MM0101CA → MM0101DA 修改方式:

(MM0101CA — External clock ; MM0101DA — Internal crystal clock)

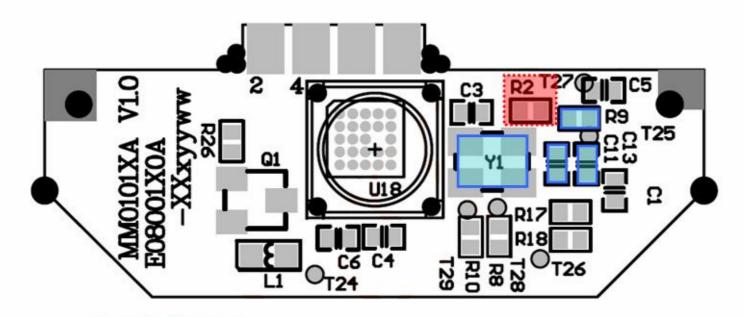
- 1. 移除R2(0Ω)
- 2. 新增Y1(24MHz crystal)
- 3. 新增C11(22pF), C13(22pF), R9(1MΩ)
